1CAN071701

July 17, 2017

SUBJECT: License Amendment Request
Application for Technical Specification Improvement to Revise Actions for
One Steam Supply to Turbine Driven Emergency Feedwater Pump
Inoperable using the Consolidated Line Item Improvement Process
Arkansas Nuclear One, Unit 1
Docket No. 50-313
License No. DPR-51

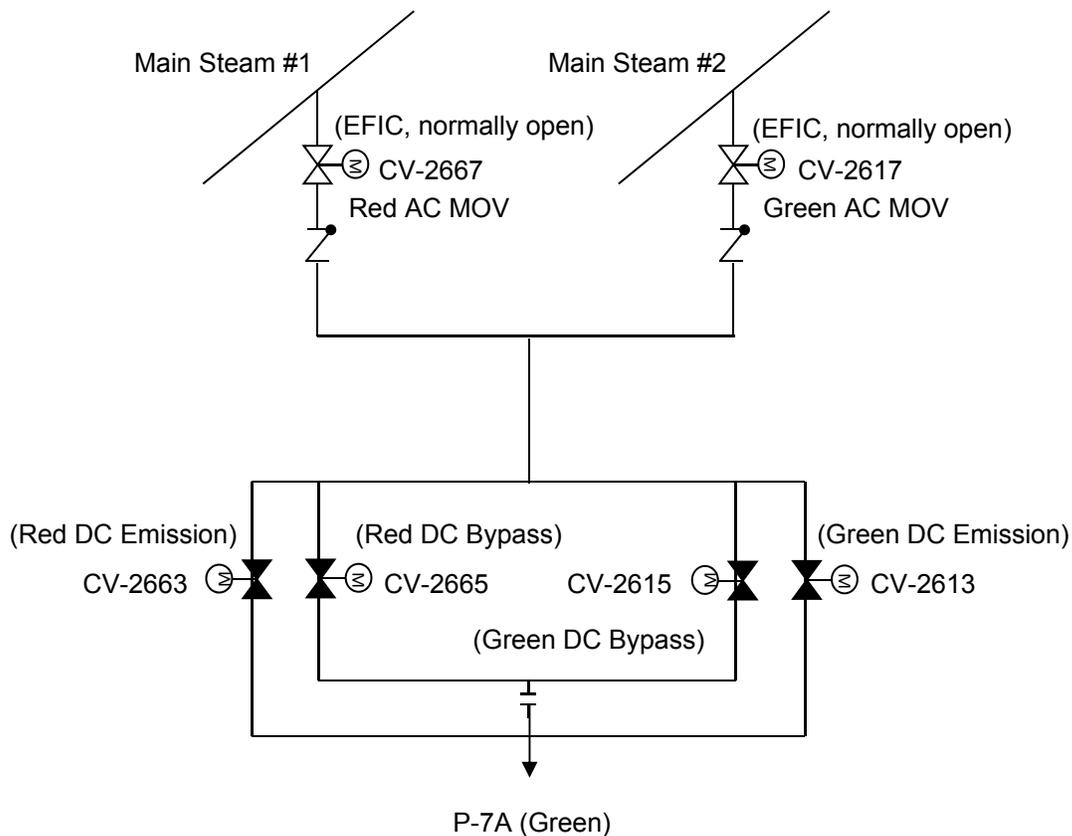
ANO-1 is a Babcock and Wilcox (B&W) design. The ANO-1 EFW system consists of two pumps; one steam turbine-driven (P7A) and one electrically motor-driven (P7B). Each pump has the flow capacity to remove heat load equal to 3½ percent full power operation, and is piped to supply the total required feedwater to either steam generator (SG) from either pump. The turbine-driven EFW pump receives steam to its turbine from either or both SGs. Further system information is contained in the ANO-1 Safety Analysis Report (SAR), Section 10.4.8. A simplified schematic of the steam input to P7A is provided below for information purposes.

Note that all motor-operated valves shown above receive an open command upon receipt of an Emergency Feedwater Initiation and Control (EFIC) signal.
